## Access Compliance Report Public Rights-of-Way (Curb Ramps)

Intersection ID: 48069Main Street:ELLIOTT\_STCross Street:FERRELL\_AVLocation:NEADA ID: CB040FEBA9E7Ramp Type:PerpInitial Pass/Fail:FailOverall Compliance:NoSeverity Score:8.75

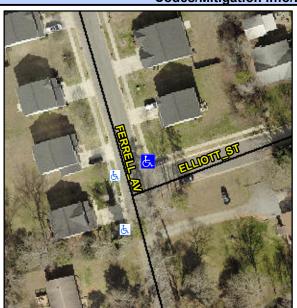
Possible Solution	
Possible Solutions:	Co
Remove & Replace Entire Ramp.	
•	No
	N/A
	N/A
	N/A
	N/A
Surveyor Notes:	N/A
N/A	N/A
	N/A
	N/A
	N/A
PROW/ADA:	N/A
Not Found, R304.5.1	N/A
·	N/A
	N/A
	N/A

Comp	liance Description	Data	Comp	liance	Description	Data
N/A	Ramp Length (in)	50.0	Yes	Ramp	Slope (%)	7.4
No	Ramp Width (in)	46.5	Yes	Ramp	XSlope (%)	2.0
N/A	Flare Type LT	N/A	N/A	Flare	Type RT	N/A
N/A	Flare Slope LT (%)	N/A	N/A	Flare	Slope RT (%)	N/A
N/A	Flare Traversable LT?	N/A	N/A	Flare	Traversable RT?	N/A
N/A	Landing Length (in)	N/A	N/A	DWS	Provided?	N/A
N/A	Landing Width (in)	N/A	N/A	DWS	Contrast?	N/A
N/A	Landing Slope (%)	N/A	N/A	DWS	Length (in)	N/A
N/A	Landing X Slope (%)	N/A	N/A	DWS	Full Width?	N/A
N/A	Landing Curb? (Y/N)	N/A	N/A	DWS	Offset (in)	N/A
N/A	Shared Landing?	N/A				
N/A	Gutter Ponding?	N/A	N/A	Gutte	r Slope (%)	N/A
N/A	Gutter Lip Ht (in)	N/A	N/A	Gutte	r X Slope (%)	N/A
N/A	Painted X Walk1?	No	N/A	Paint	ed X Walk2?	N/A
	X Walk 1 Direction	To W		X Wa	lk 2 Direction	N/A
N/A	X Walk 1 Width (in)	N/A	N/A	X Wa	lk 2 Width (in)	N/A
	X Walk 1 Slope (%)	3.9		X Wa	lk 2 Slope (%)	N/A
	X Walk 1 X Slope (%)	1.9		X Wa	lk 2 X Slope (%)	N/A
